Radisson Casual Wear (Extension)

Sreerampur, Kalampur, Dhamrai, Dhaka.

2 March 2025

2. Observation

Observation 1: Lack of information in design report. (New Building).

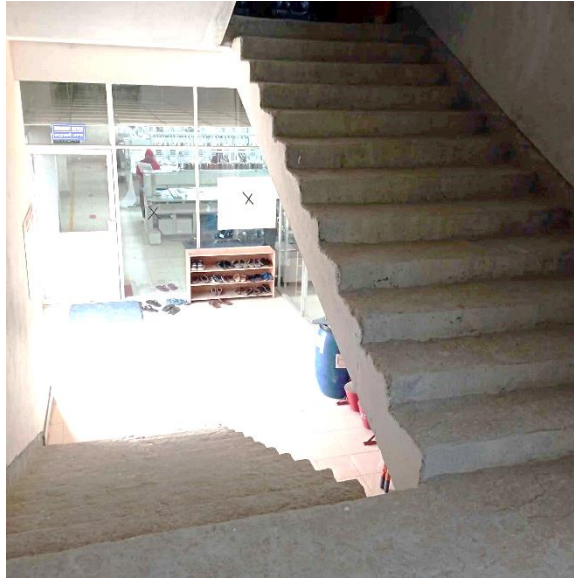
Description: SMRF is considered as a framing system, but no supporting calculation or justification is provided. Besides, concrete strength is considered as 24.13 MPa (3500 psi) without any test report. Also, no sample calculation is provided for punching shear for the foundation. The building engineer is required to update the design reports based on in situ concrete strength in compliance with section 1.9.1 (part-6, BNBC).

Item No.	Observation	Action Plan	Timeline
1.	Lack of information in the design report. (New Building).	The building engineer is required to update the design reports based on in situ concrete strength in compliance with section 1.9.1 (part-6, BNBC).	within 6 weeks

2.		Take a minimum 4 (100mm diameter) concrete core from column (lower level) to verify the in-situ concrete strength.	within 6 weeks
3.		Implement remediation work if required.	within 6 months

Observation-3: Falling hazard at the staircase (New Building).

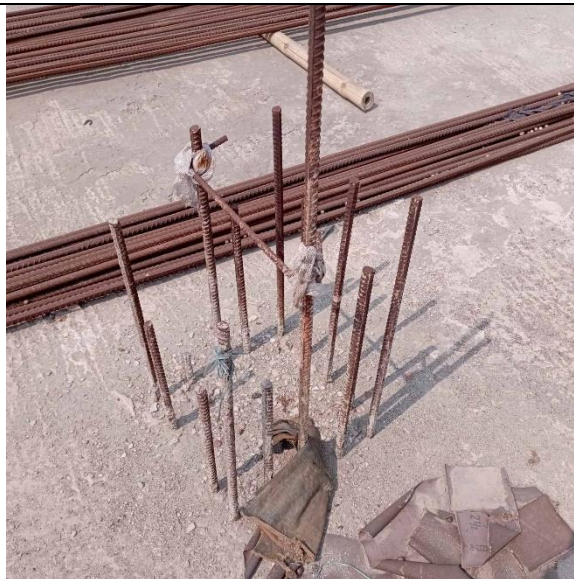
Description: No railing was found at the staircase, which is prone to a falling hazard. The building engineer is required to install railing to avoid a falling hazard.

4.	Discrepancy in provided drawing (New Building).	The building engineer is required to update the as-built drawing.	within 6 weeks
5.	Falling hazard at the staircase (New Building).	The building engineer is required to install railing to avoid a falling hazard.	Immediate

Observation-5: Lack of lateral stability and foundation details (Multipurpose Shed, Staff Dining & Kitchen).

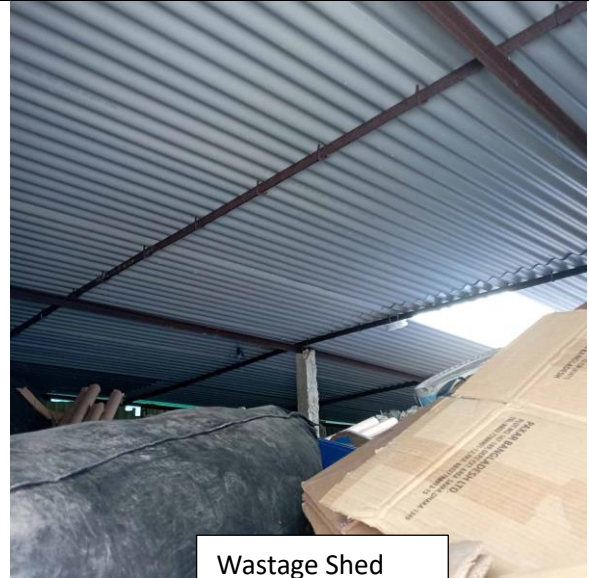
Description: No bracing system is provided for these structures (strut, vertical & horizontal bracing). Also, poor connection was observed. Also, no foundation detail and as-built drawing was available. The building engineer is required to check the lateral stability with connection adequacy check and prepare a design report as per 1.9.1 BNBC.

7.	Lack of lateral stability and foundation detail details (Multipurpose Shed, Staff Dining & Kitchen).	The building engineer is required to check the lateral stability with connection adequacy check and prepare a design report as per 1.9.1 BNBC.	within 6 weeks

8.		Prepare as-built drawing with foundation and connection details.	within 6 weeks
9.		Implement remediation work if required.	within 6 months
10.	Absence of bracing system and foundation details (Fabric Shed, Wastage Shed, Leftover Store Shed).	The building engineer is required to check the bracing requirement, connection & foundation adequacy and prepare a safety check report.	within 6 weeks

Observation-6: Absence of bracing system and foundation details (Fabric Shed, Wastage Shed, Leftover Store Shed).

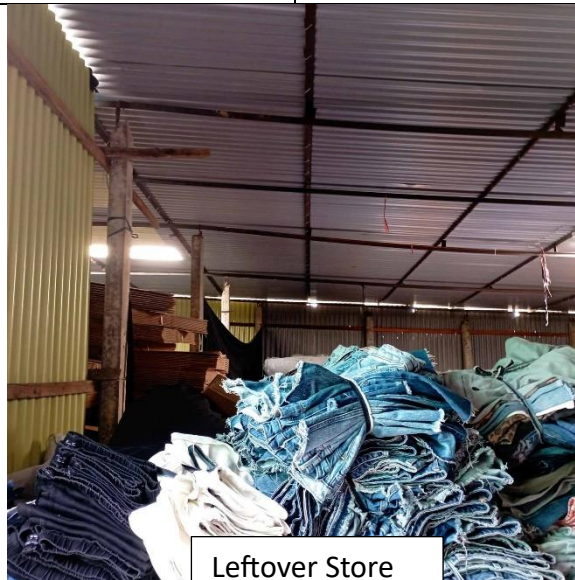
Description: No bracing system is provided for these structures (strut, vertical & horizontal bracing). Poor connection was observed. Also, no foundation detail and as-built drawing was available. The building engineer is required to check the bracing requirement with connection adequacy check and prepare a safety check report.

11.		Prepare as-built drawing with foundation and connection details.	within 6 weeks
12.		Implement remediation work if required.	within 6 months
13.	Lack of building permit layout/drawing from the local authority. (All structures).	The factory is required to collect building permit layout/drawing from the relevant local authority for all structures within the factory.	within 6 months

Observation 7: Lack of building permit layout/drawing from local authority. (All structures).

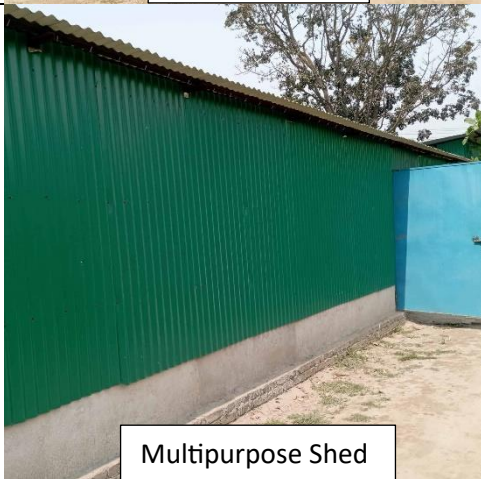
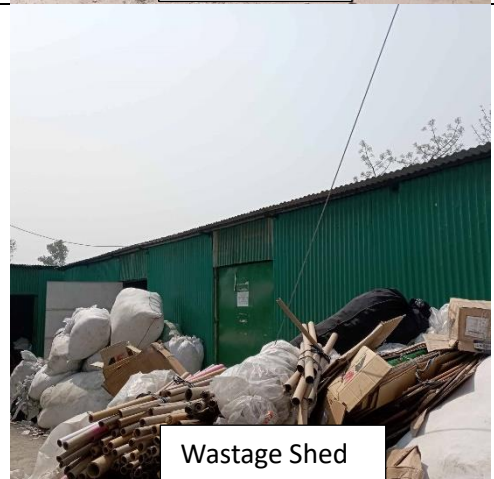
Description: No permit drawing was available from the local authority for any of the structure. The factory is required to collect building permits from the relevant local authority for all structures within the factory.
